Certified Action of the City of Raleigh Planning Commission

Case File / Name: SP-56-09 / BB&T North Hills

Nature of Case: The demolition of two bank institutions with drive thru on a single parcel and the construction of a 2-story; 11,080 square foot bank with drive thru and ATM.

SP-56-09 BB&T North Hills – Site Plan

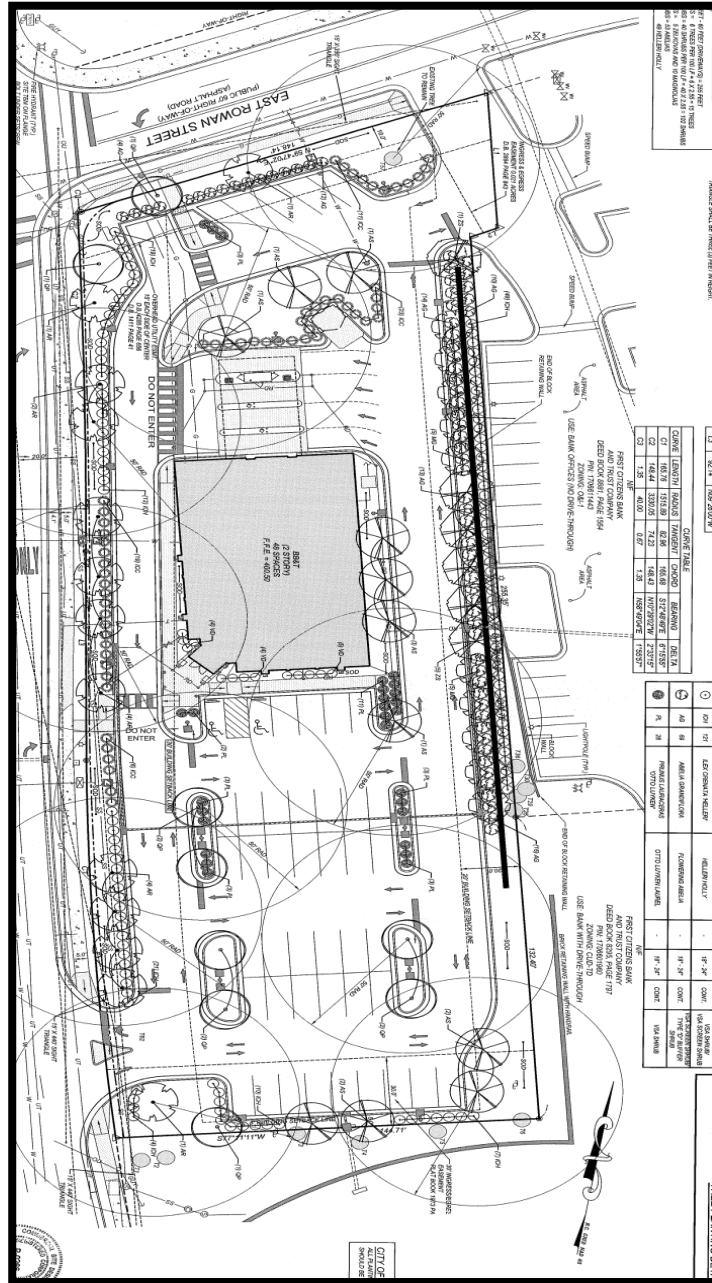
- (1) That in accordance with 10-2132.2(d), standard 4, that the site plan incorporate public art or additional landscaping at the northwest property corner;

Comment	Response
1) The Commission recommends that the northwest corner property receive a design treatment more in keeping with the prominence of its location. Ideally, the building should be placed directly at the corner. At minimum, the two proposed corner parking spaces should be removed in favor of providing pedestrian-oriented and accessible space, such as a plaza area, added landscaping/ planters, public art, or similar place-making features.	BB&T is willing add additional landscaping and/or public art directly on the corner of the site, however they would like to do so without removing any parking spaces. Given the office component of the proposed building, there will be 37 employees at this facility. Considering the site only has 48 spaces, that potentially only leaves 11 spaces for customers which is a minimal amount and of concern to the Bank. Obviously, losing two additional parking spaces would only exacerbate this issue.

2) If the building remains in its proposed orientation, provide a flowering understory tree or similar ornamental landscaping treatment at the south-facing main entrance [commensurate with Code Sec. 10-2132.2(d)(2)].	In lieu of the two laurel shrubs that were proposed in the landscape island just off of the southwest building corner, we will install a Kousa Dogwood tree.

3) Provide a more prominent pedestrian connection from the street sidewalk to the building entrance across the drive-through lane through the use of distinctive walkway materials (e.g., contrasting pavers), and/ or greater crosswalk width [commensurate with Code Sec. 10-2132.2(d)(1)].	In lieu of the typical painted crosswalks, we will install brick paver or stamped concrete (in brick pattern) crosswalks for both the crosswalk at the drive-through exit as well as for the crosswalk near the building entrance (for connection to Six Forks Road). Likely the crosswalk at the drive-through exit will need to remain the typical width (6-foot), however the crosswalk for the connection to Six Forks Road (nearest the building entrance) will be wider than is typical (in the range of 10 to 12 feet).

4) To reduce the visual impact of the retaining wall, include vining	We will install Carolina Jasmine along the top of the retaining wall to allow for a

plants designed to drape over or climb upon the wall surface; additionally, retaining wall materials should be of a color similar to the primary building (commensurate with Code Sec. 10-2132.2(d)(4)).

5) Rather than the proposed red maples, substitute a variety of maple less susceptible to urban stress (e.g., *Acer barbatum*) [commensurate with Code Sec. 10-2132.2(d)(4)].

6) Given the property's thoroughfare frontage, include bicycle racks in the site plan [commensurate with Code Sec. 10-2132.2(d)(2) & (5)].

plantings that will cascade down the face of the wall. The block for the retaining wall will also be specified to match the main brick color on the Bank building.

We will propose Southern Sugar Maples (*Acer Barbatum*) in lieu of the red maples that we currently are proposing.

The Bank will install bicycle racks in close proximity to the front building entrance.
